**ADVISORY BOARD ON
RADIATION AND WORKER HEALTH
National Institute for Occupational Safety and Health**

**Review of the Rocky Flats Plant Special Exposure Cohort (SEC) Petition,
SEC-00030**

Second Supplemental Report on the Rocky Flats SEC Petition

**Contract No. 200-2004-03805
Task Order No. 5
SCA-SEC-TASK5-0052, Second Supplemental Report**

Figure 2. 1966 % Notional Dose versus Final Neutron Dose

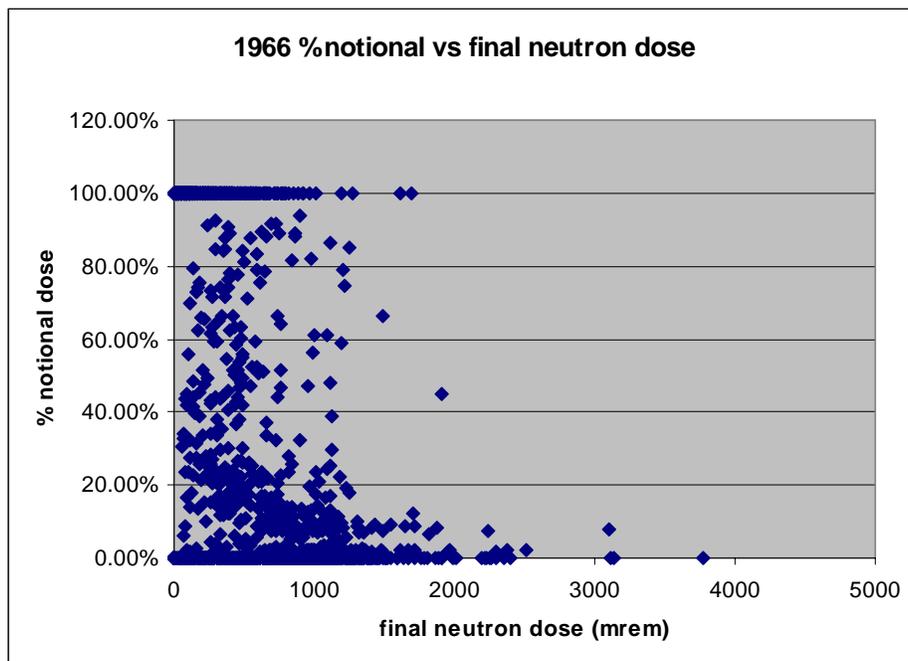
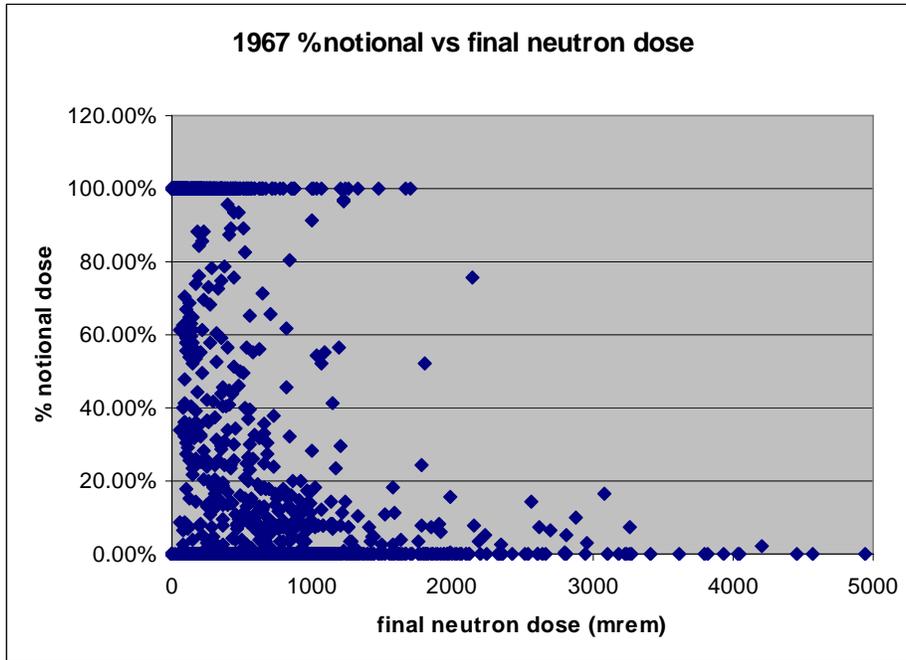
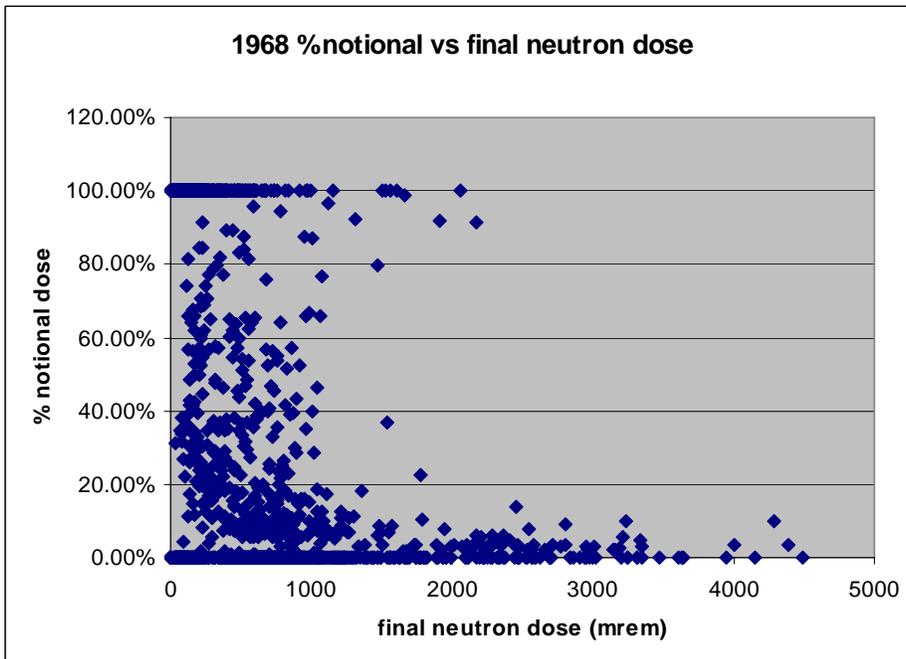
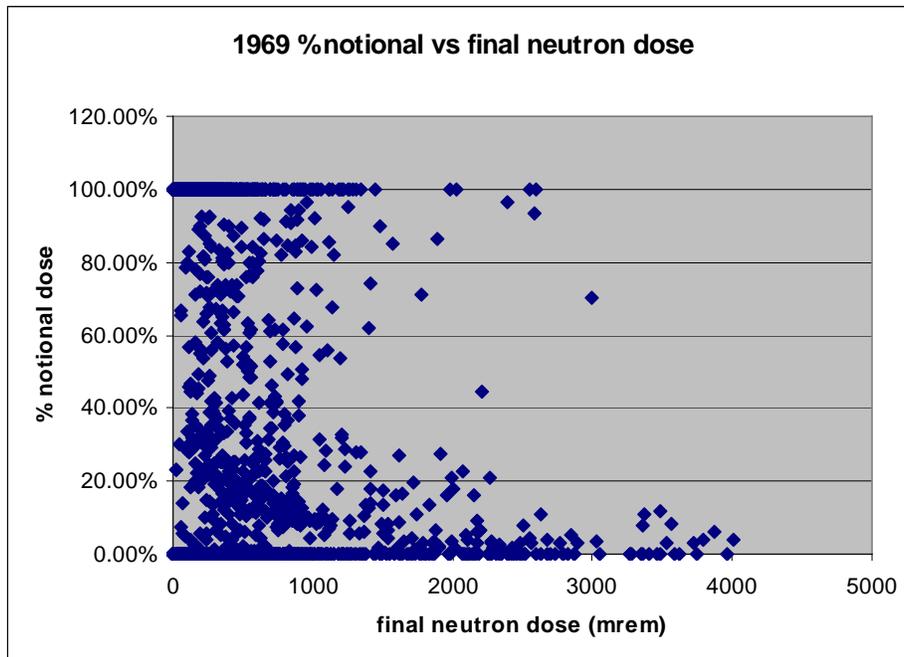
For 1965 and later years, the highest neutron doses were generally the measured ones, with small exceptions. This indicates that the problem of non-monitoring of some workers at high risk of exposure was likely confined to the 1959–1964 period.²⁹ The charts for 1959–1965 were provided in SC&A 2007a. Figures 2 through 5 show the corresponding charts for 1966 through 1969.

In all these cases, the highest doses are the measured doses. This indicates that when the monitoring increased in 1965, the coverage of the workers with high exposure potential was more complete.
